Interpreting The Secretary of the Interior's Standards for Rehabilitation

Subject: Incorporating Solar Panels in a Rehabilitation Project

August 2009, ITS Number 52

Solar panels installed on the flat roof.

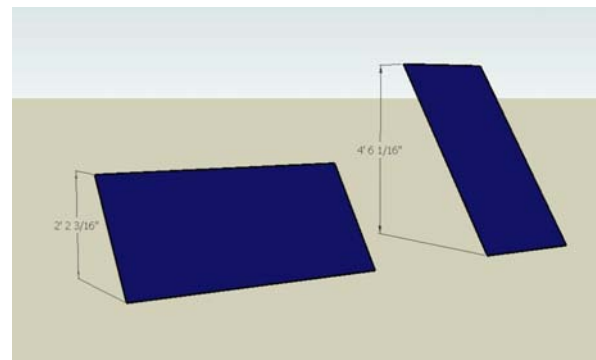
The rehabilitation of this mid-nineteenth century mill incorporated a large, roof-mounted photovoltaic installation. Although the historic building does not have a parapet wall at the roofline, the height of the building and the arrangement of the panels render the entire installation invisible from the ground. It is important to note that the panels are placed horizontally. Had the panels been installed with a vertical tilt, the angle required to maximize efficiency would have caused the panels to extend significantly higher above the roof. Simply changing the direction in which the panels are tilted can affect their visibility and reduce their impact on the character of the historic property.

Because of the size of this historic mill, a large array of solar panels could be installed on the flat roof without being seen from the ground.

By placing the panels horizontally, the overall height of the installation and its visibility is reduced.
